## 2009 EXPLANATION OF SIGNIFICANT DIFFERENCES DOVER MUNICIPAL LANDFILL SUPERFUND SITE DOVER, NEW HAMPSHIRE

JUNE 30, 2009

UNITED STATES ENVIRONMENTAL PROTECTION AGENCY REGION 1, NEW ENGLAND

**Figure 12** – Plan view of the proposed Source Control groundwater extraction system, SC-Ex. The groundwater extraction system would follow the path of the air-sparging trench.

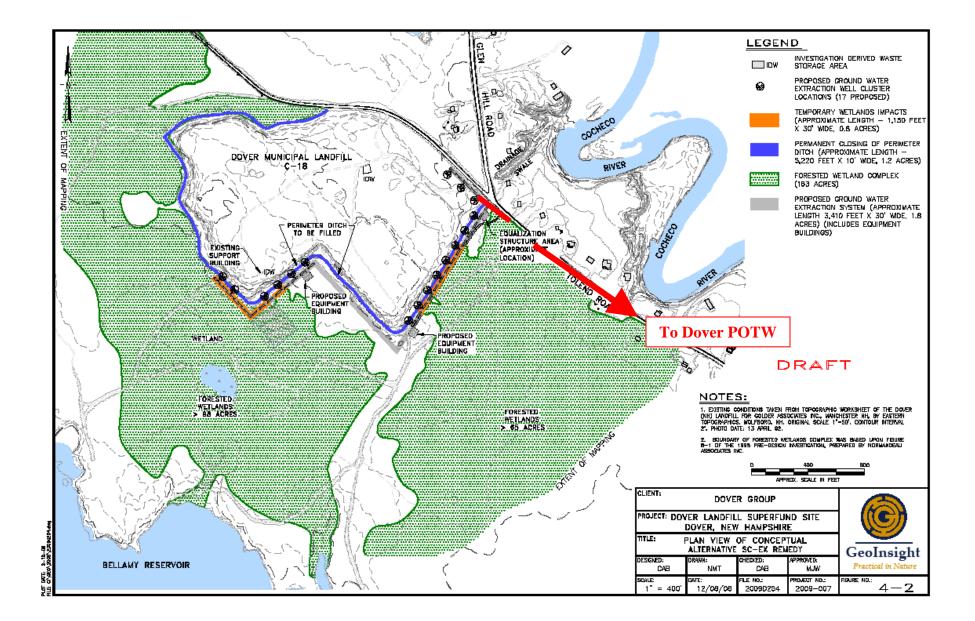
This ESD seeks to change only the air-sparging trench and its associated components of the Source Control remedy shown on Figure 3. Its replacement, SC-Ex, groundwater extraction, will actively withdraw contaminants from the subsurface. A comparison of the Original 1991 ROD remedy, the 2004 AROD remedy and the proposed 2009 ESD remedy is outlined in Table 1, below:

Refer to Figure 11 for a schematic of the 2004 AROD air-sparging trench and Figures 12 and 13, for a schematic and plan view, respectively of the proposed groundwater extraction system. The components of the air-sparging trench that will also be affected by this ESD are the sheet piling walls that were to be installed on the northern and southern edges of the landfill to ensure that flow was directed to the air-sparging trench and the Southwest Landfill THF hotspot remedial effort. The sheet piling walls will not be necessary as hydraulic control can be exercised through additional extraction wells. The recovery of THF in the southwestern hotspot may be advantageous; however, it is not required as recovery may be performed at the edge of the landfill in the extraction wells. In SC-A it was believed that the air-sparging trench was incapable of treating the high concentrations of THF present in this area. However, with extraction wells that is not a concern. It is therefore anticipated that the recovery of THF from the hotspot will be a subject of design considerations.
